Software Update & Rework Requirements

Bulletin Type:	Service Campaign Bulletin
Reference Number:	14 F 001
Campaign Reference:	04F
Attention:	Service Managers and Retailer Technicians
Affected Vehicles:	720S
Situation:	Service Campaign bulletin to address a number of concerns identified after vehicles left production.
Procedure:	Please refer to the instructions outlined in this document to complete the below checks/rework.
Date:	29 th August 2017

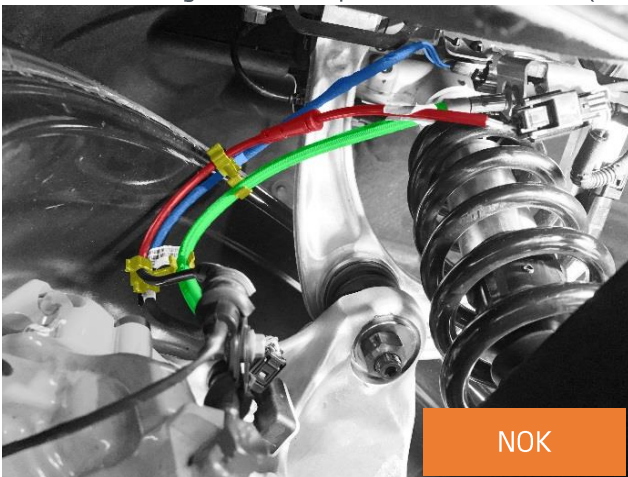
McLaren Automotive has identified that some vehicles may have the front brake pad wear sensor cable routed incorrectly, causing it to come into contact with the wheel when the steering wheel is turned on full lock.

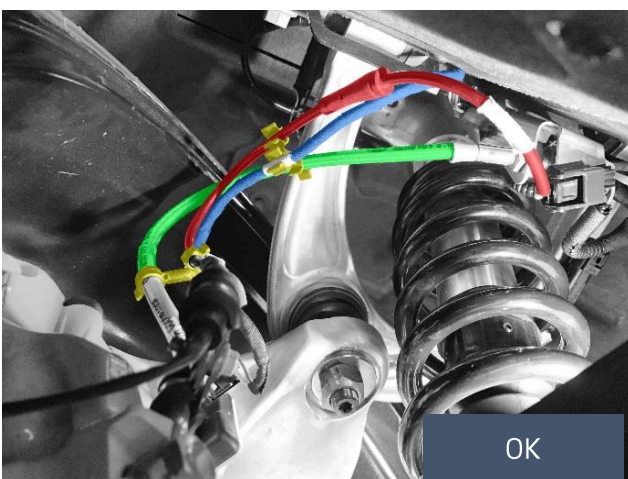
NOK - The brake pad wear sensor cable and clip are routed incorrectly, as they are above the brake pipe (shown in green).

OK - The brake pad wear sensor cable and clip are routed correctly, as they are below the brake pipe.

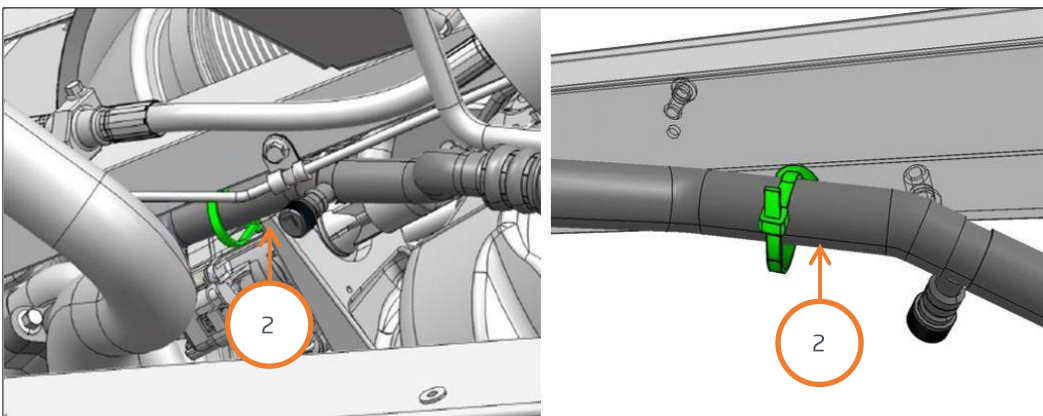
McLaren Automotive has identified that the firtree cable tie which secures the low-pressure air conditioning pipe was not fitted. If left unchecked a clash with the coolant hose may occur.

Fit a new firtree cable tie 00RL001 into the respected hole in the left rear side of the frame (1).

Ensure that the low-pressure air conditioning pipe (2) is correctly secured to the firtree cable tie. Using a pair of pliers, pull the firtree cable tie to tighten, ensuring that there is no play in the firtree cable tie to the air conditioning pipe prior to snipping the excess off the firtree cable tie.
